Council Communication

Request: Combined public hearing on the request of Legacy CB, LLC for final plat approval of six-lot commercial subdivision to be known as The Marketplace, Replat 3, legally described as being a replat of Lots 1 and 2, The Marketplace Replat 2, and to amend the adopted planned commercial development plan for the Marketplace Subdivision.

CASE #SUB-18-010

CASE #PC-18-001

THE MARKETPLACE REPLAT 3
FINAL PLAT
COUNCIL BLUFFS, IOWA

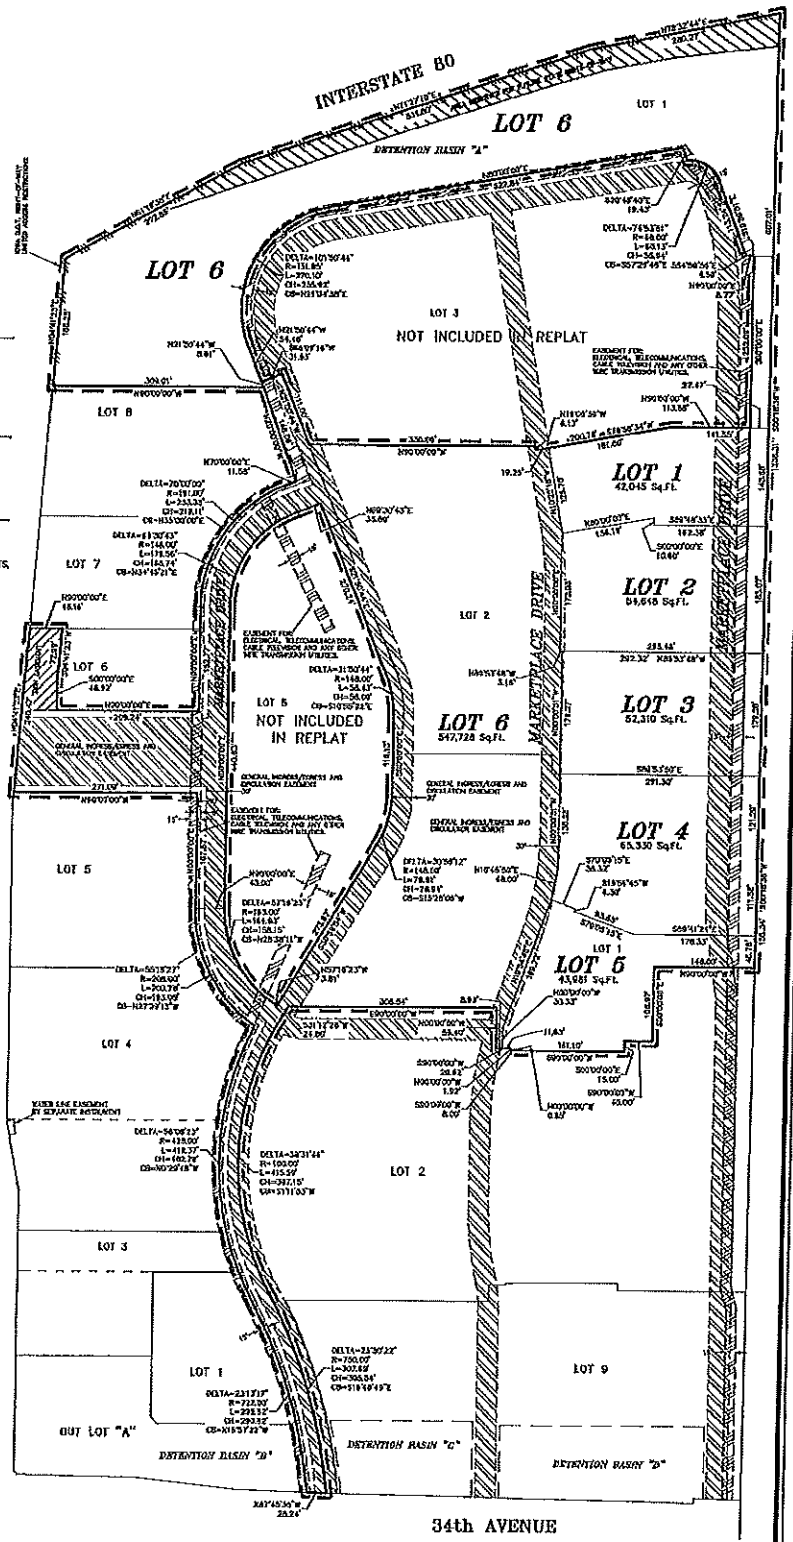
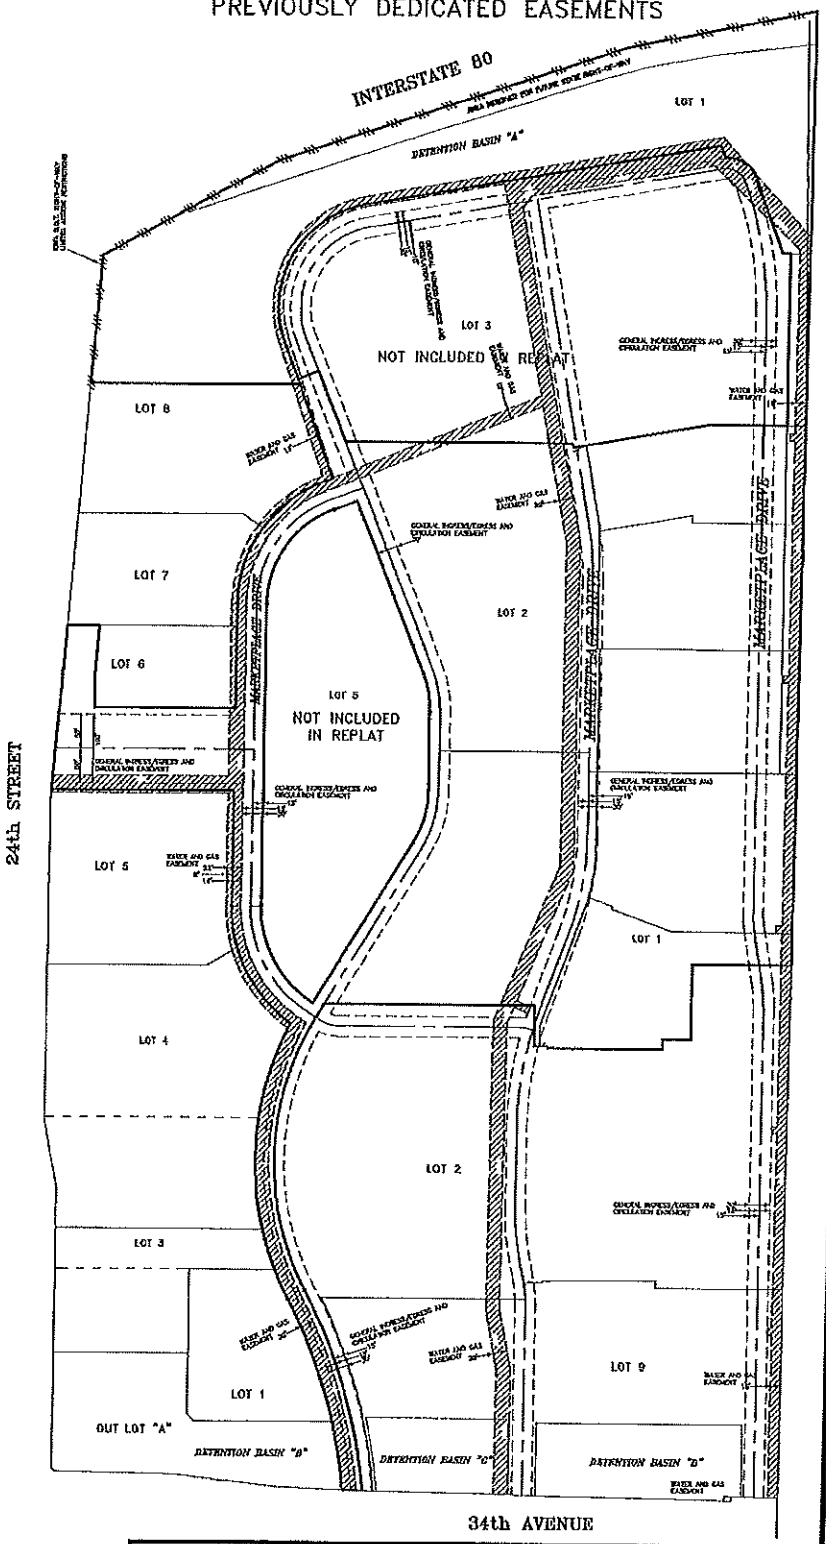
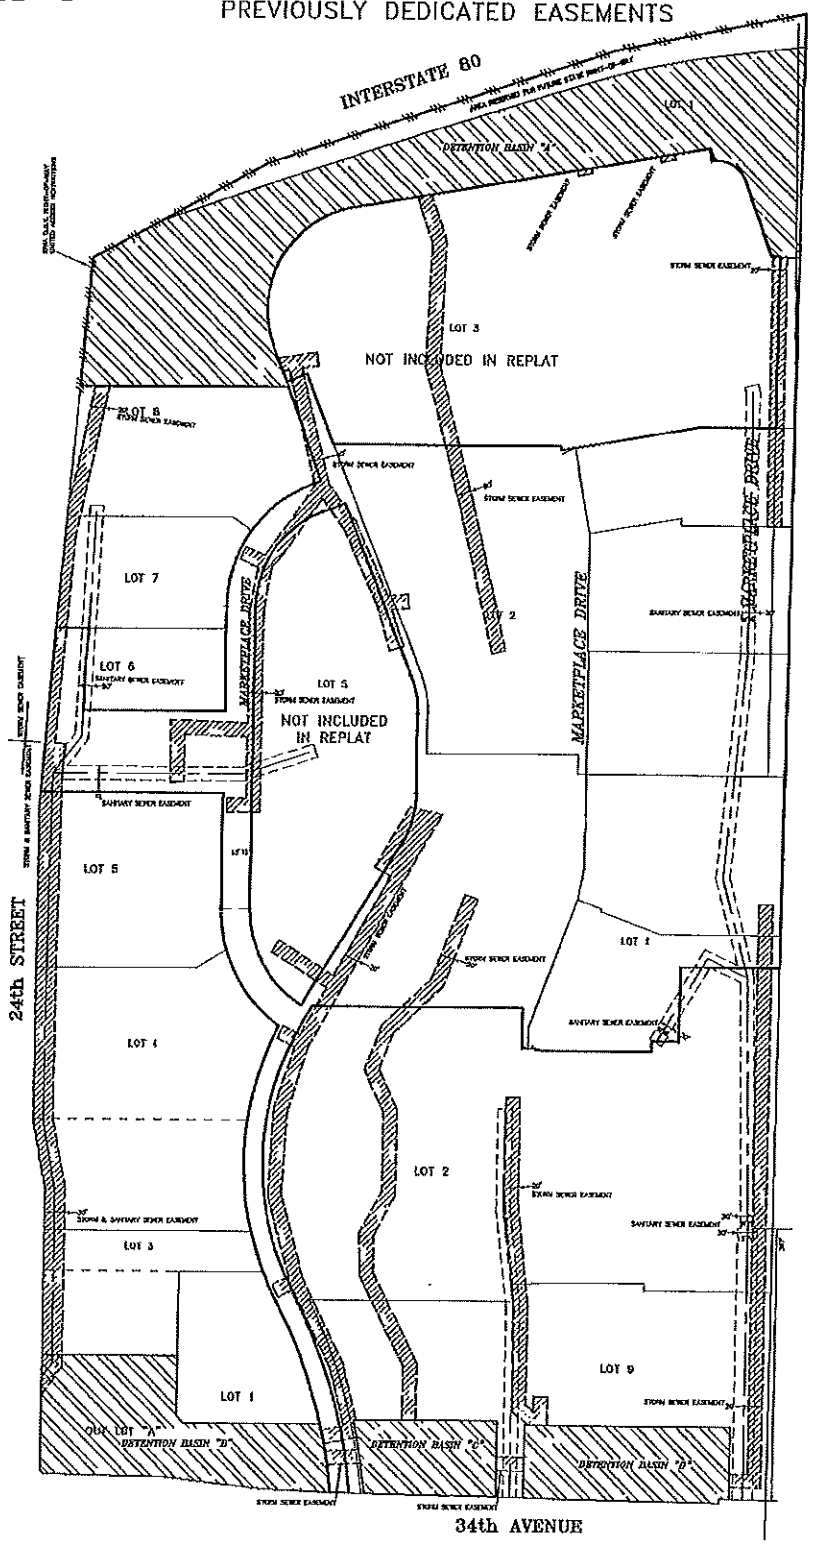
1. Label all Marketplace Subdivision names and their associated lots on the final plat (e.g., Lot 2, The Marketplace).
2. Label the acreage total for each lot included in The Marketplace, Replat 3.
3. All utilities shall be installed underground.

1. Final plat approval of a six-lot commercial subdivision to be known as The Marketplace, Replat 3, legally described as being a replat of Lots 1 and 2, The Marketplace Replat 2, as shown in Attachment 'B', subject to the following conditions:
   a. Prior to executing the final plat, any corrections required by the Community Development Department and/or Public Works Department shall be incorporated into the final plat document.
   b. All utilities shall be installed underground
